October 9, 2020

Ms. Nancy Rumrill
U.S. Environmental Protection Agency, Region 9
Drinking Water Protection Services, WTR-4-2
75 Hawthorne Street
San Francisco, California 94105

Re: Transmittal of Supplemental Information in Support of Application for Underground Injection Control Permit, Florence Copper Project, Florence, Arizona

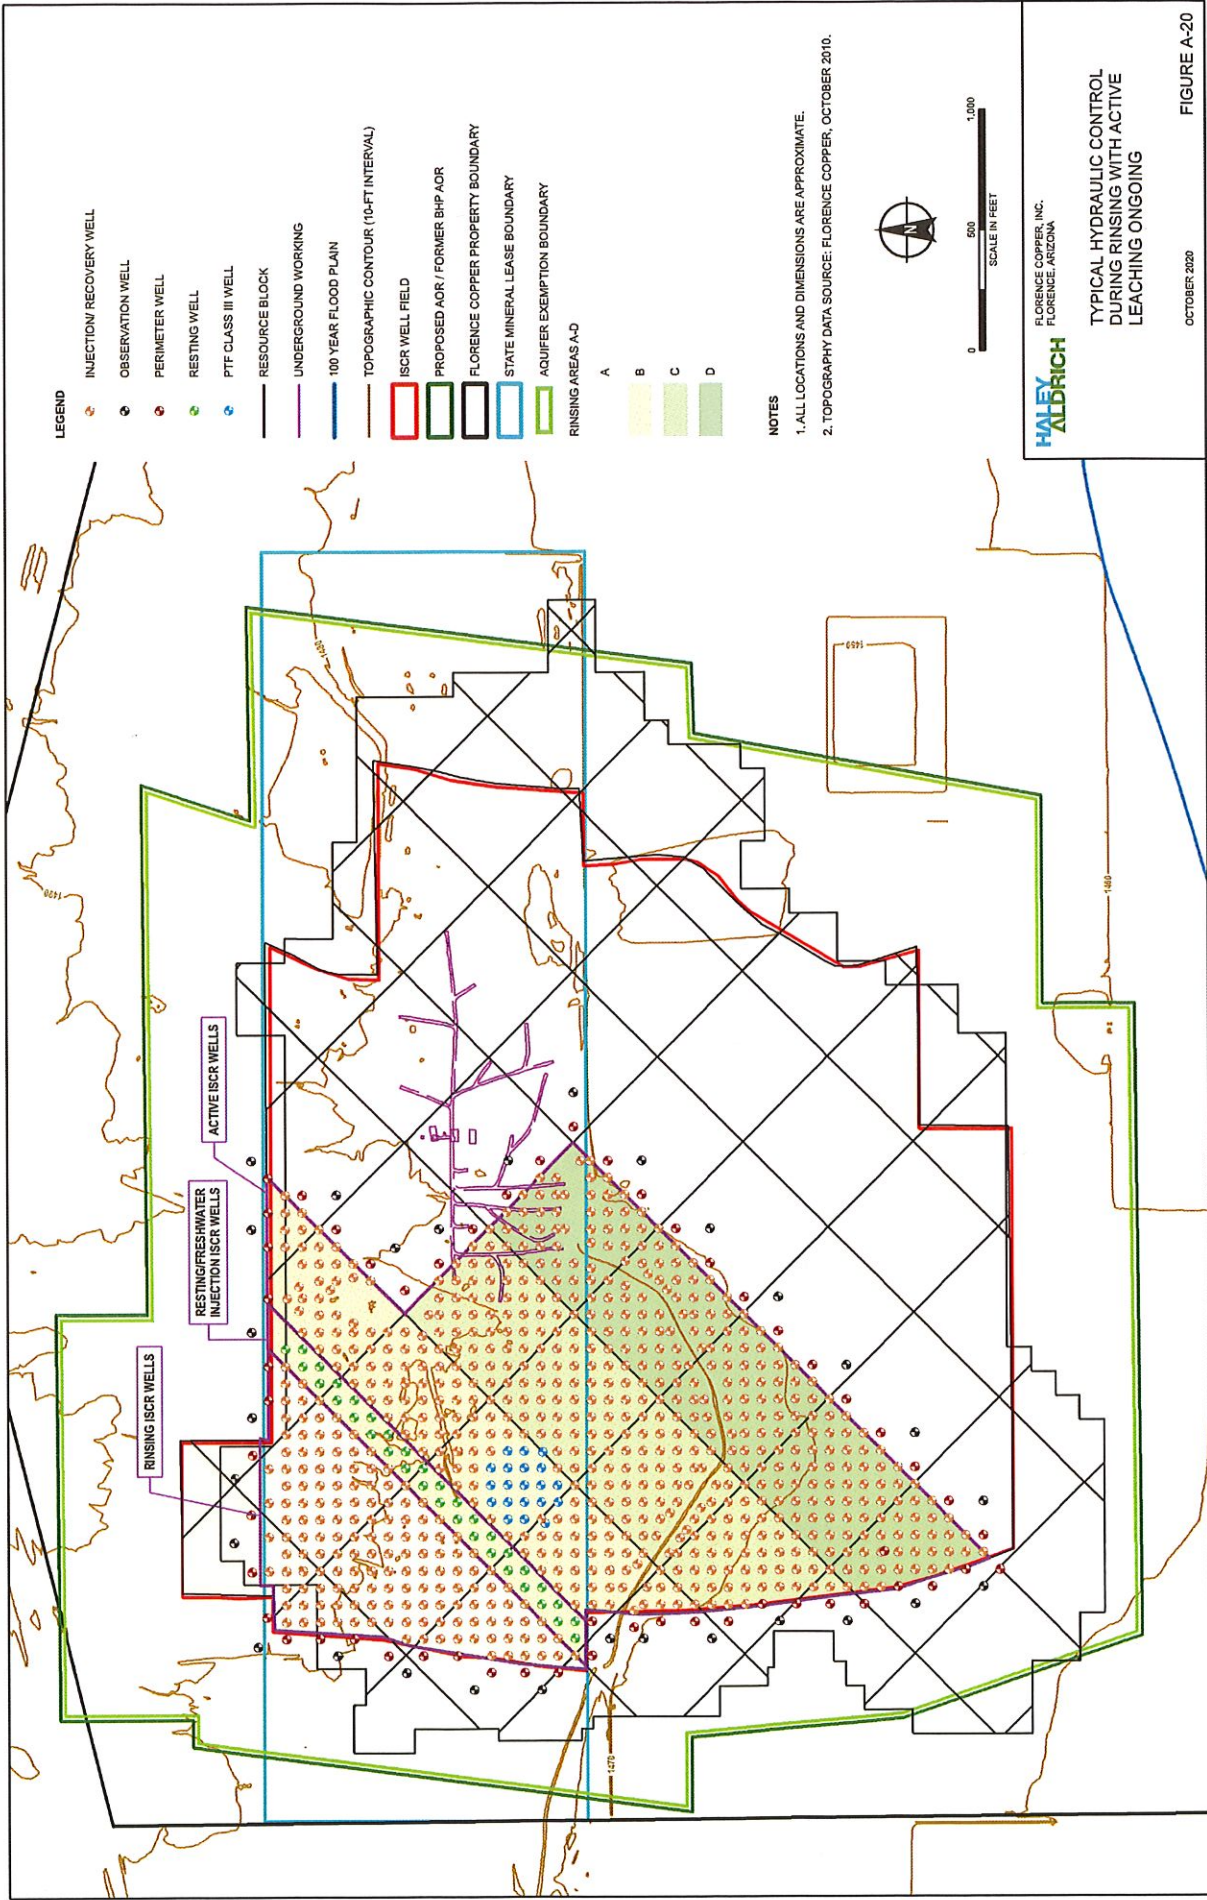
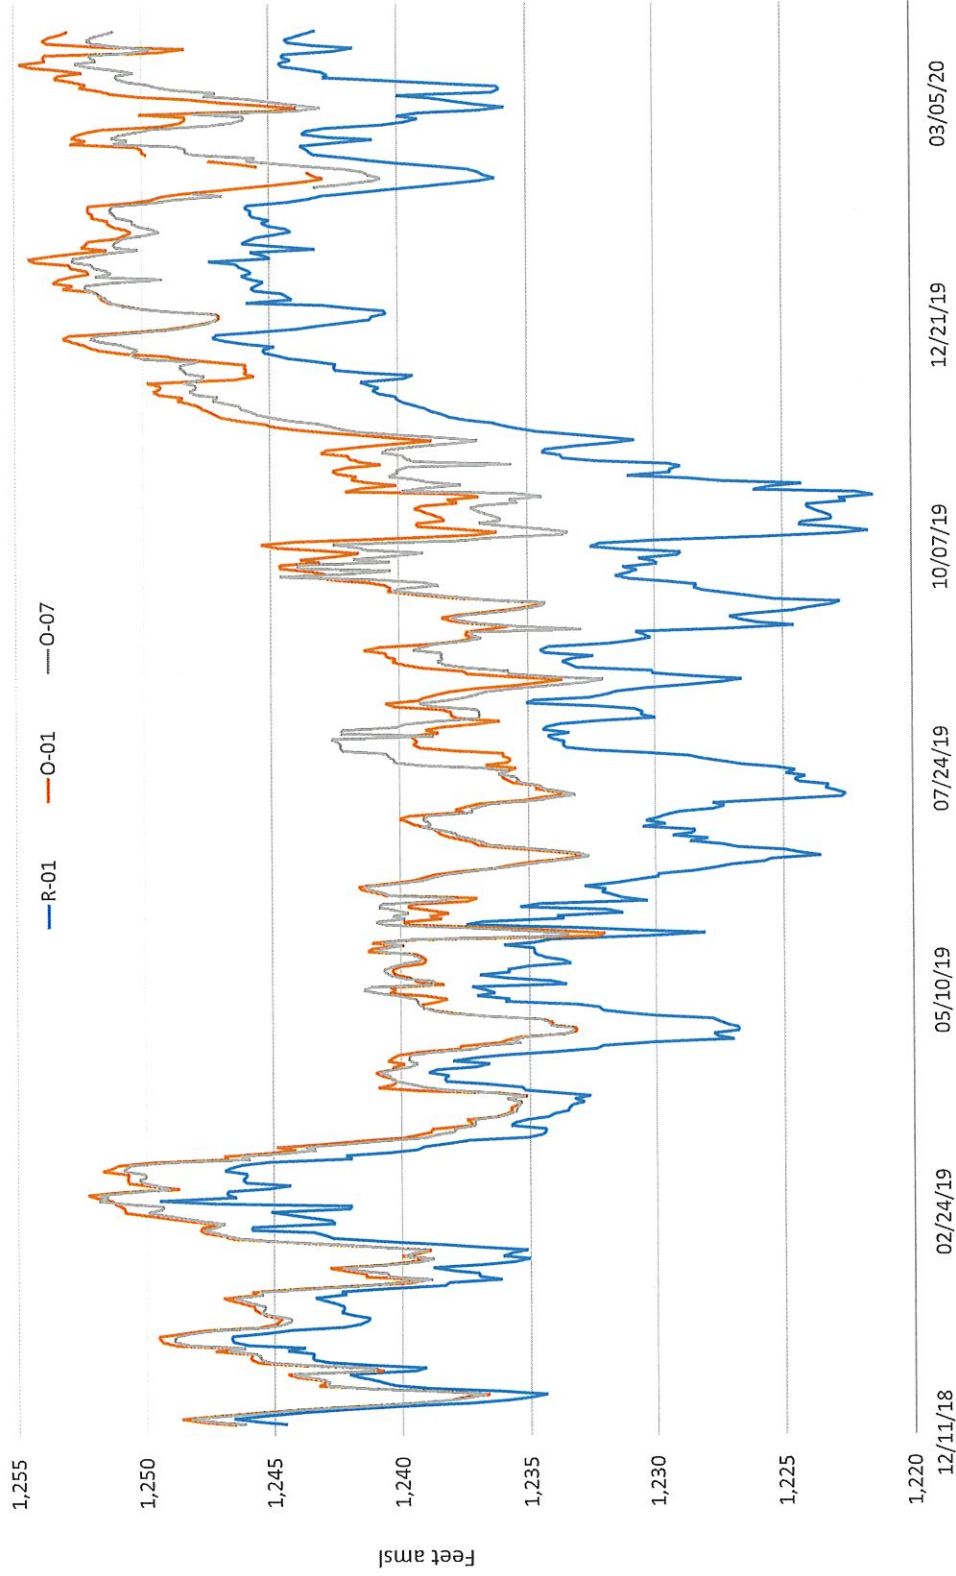
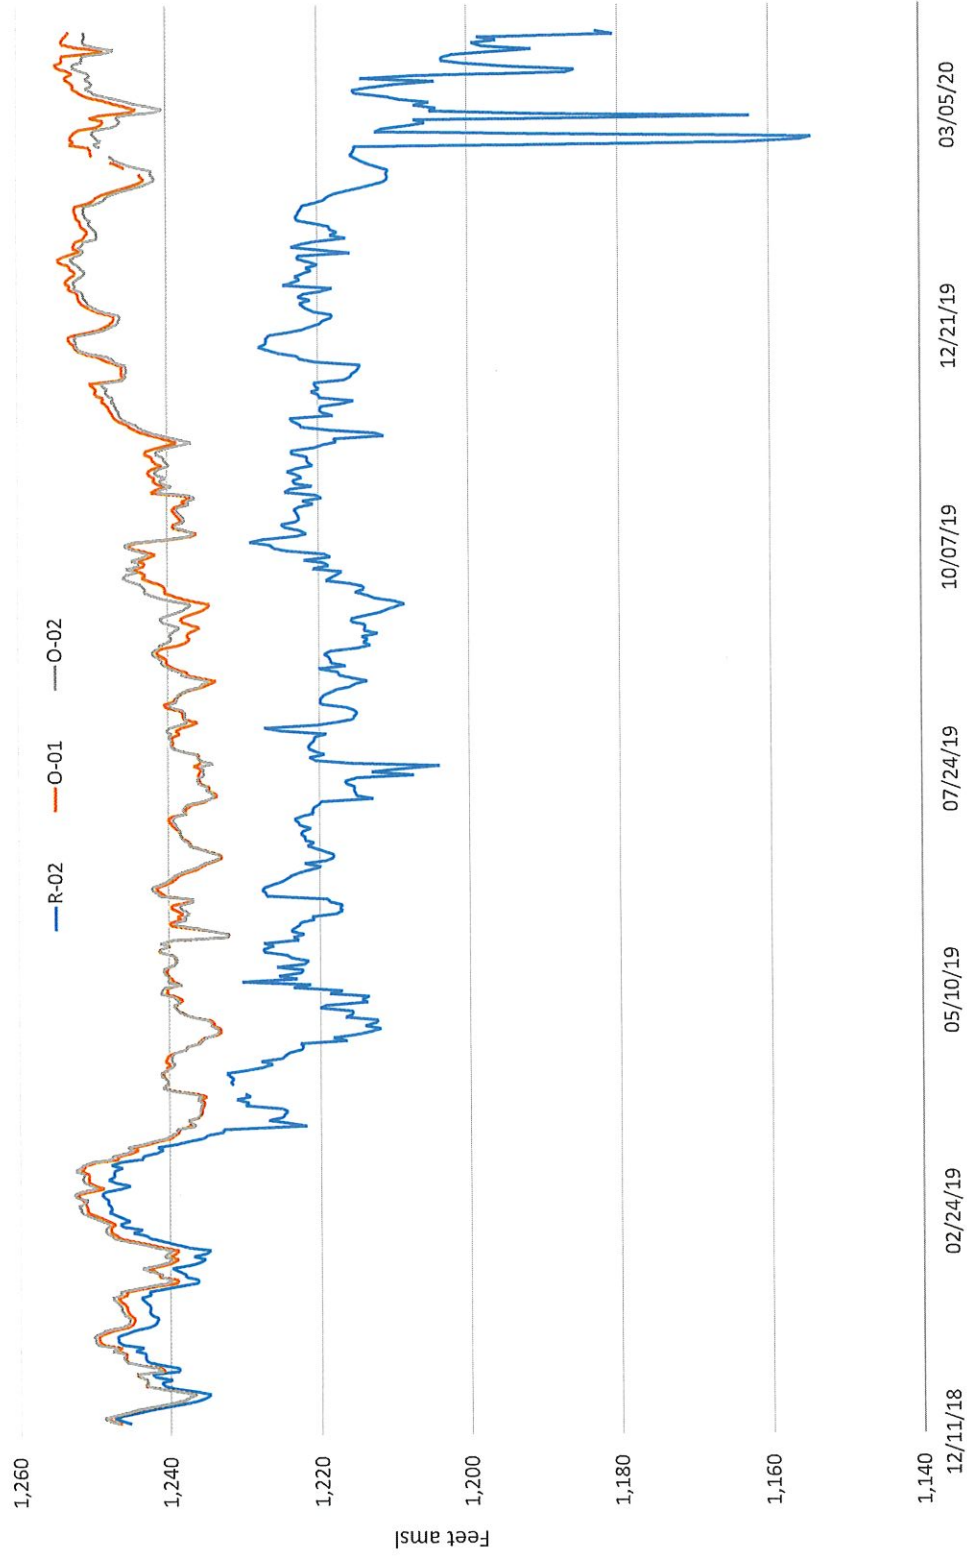
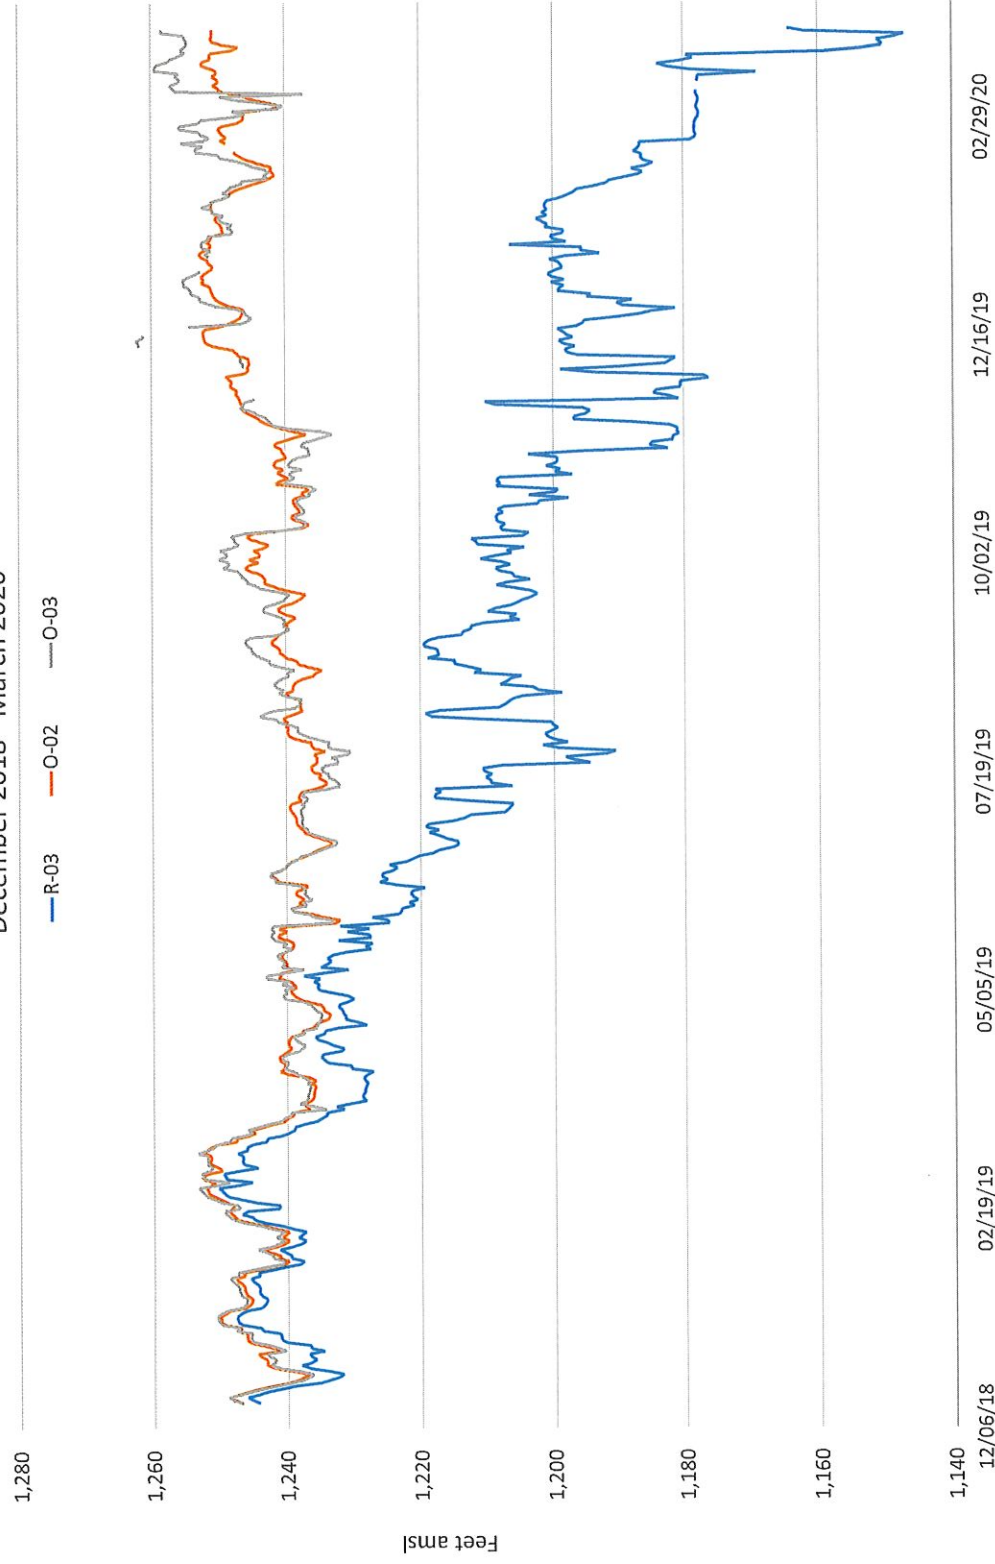
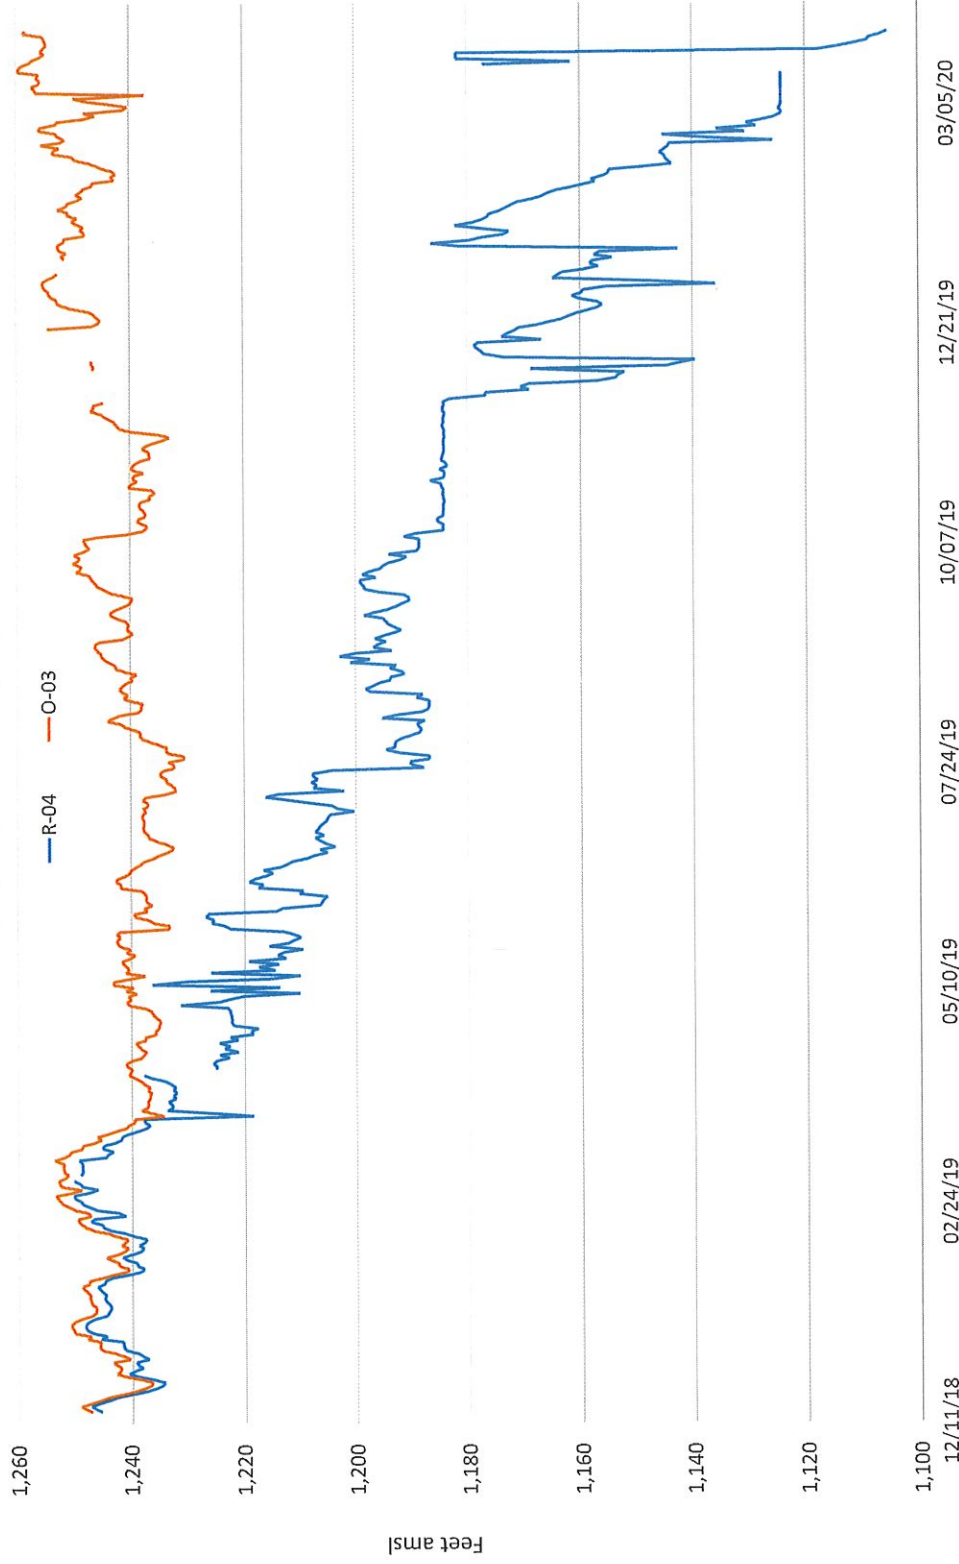
The USEPA requested that Florence Copper provide hydraulic control data from operation of the PTF wellfield.

Daily water levels measured at the PTF observation and recovery wells are plotted on Figures 1 through 8 for the period of operations spanning from December 2018 through the end of the second quarter of 2020. Data for quarter 3 of 2020 are currently being compiled and are not yet available for review. Figure 9 shows the relative locations of the wells for which water levels are plotted on Figures 1 through 8. The water level data plotted on Figures 1 through 8 indicate groundwater elevations at the perimeter of the PTF wellfield were consistently higher than groundwater elevation within the wellfield, confirming the over-pumping sustained hydraulic control effectively and maintained an inward gradient during PTF operations. These data also show that Florence Copper has maintained the daily average minimum 1-foot inward hydraulic gradient between paired observation and recovery wells since the commencement of PTF operations on December 15, 2018.

The groundwater elevation comparison required by the Temporary APP and Part II.E.1.b of the UIC permit uses recovery and observation wells at the corners of the PTF wellfield in relatively close proximity to one another on adjacent sides of the wellfield. Because the observation wells were constructed at the edge of the PTF wellfield using the same spacing as the injection and recovery wells, each observation well experiences drawdown from two recovery wells. This configuration effectively means that Florence Copper must demonstrate inward groundwater flow from two directions in a relatively small area (a 71-foot distance in two directions), and that the 1-foot differential demonstration is dependent on the hydraulic conductivity of the oxide zone between the recovery and observation wells.

Because the hydraulic conductivity of the oxide zone is relatively high, the cone of depression between the recovery and observation wells is relatively flat. Despite this condition, and the fact that pumping rates at the PTF wells were relatively low (approximately 51 gallons per minute [gpm] per well over approximately 640 feet of screen in each injection well), Florence Copper was able to successfully maintain the required 1-foot differential throughout PTF operations through real-time monitoring and active management of pumping rates.
